# City of Santa Barbara California

## STAFF HEARING OFFICER STAFF REPORT

**REPORT DATE:** October 5, 2017  
**AGENDA DATE:** October 11, 2017  
**PROJECT ADDRESS:** 1540 Franceschi Road (MST2017-00355)  
**TO:** Susan Reardon, Senior Planner, Staff Hearing Officer  
**FROM:** Planning Division, (805) 564-5470  
 Jessica W. Grant, Acting Senior Planner *JWG*  
 Stephanie Swanson, Assistant Planner

PROPOSED SOUTH ELEVATION  
 SCALE: 1/8" = 1'-0"

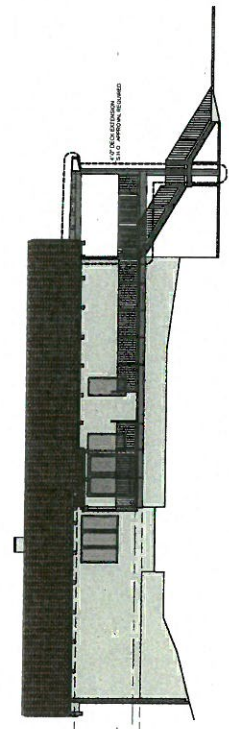
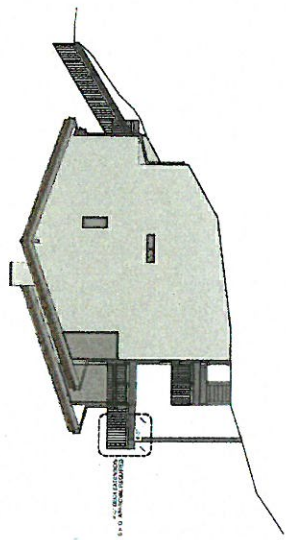
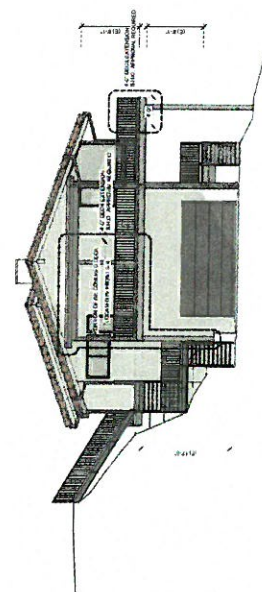
1. The proposed deck and stair encroachment is aesthetically appropriate and supportable due to the constrained site.
2. The encroachment is not significantly visible from Franceschi Road, Alameda Padre Serra, and the City, due to screening vegetation.
3. The encroachment does not pose consistency issues with the Single Family Design Board Guidelines.
4. The applicant is to return with the proposed deck light fixture represented on the elevation.
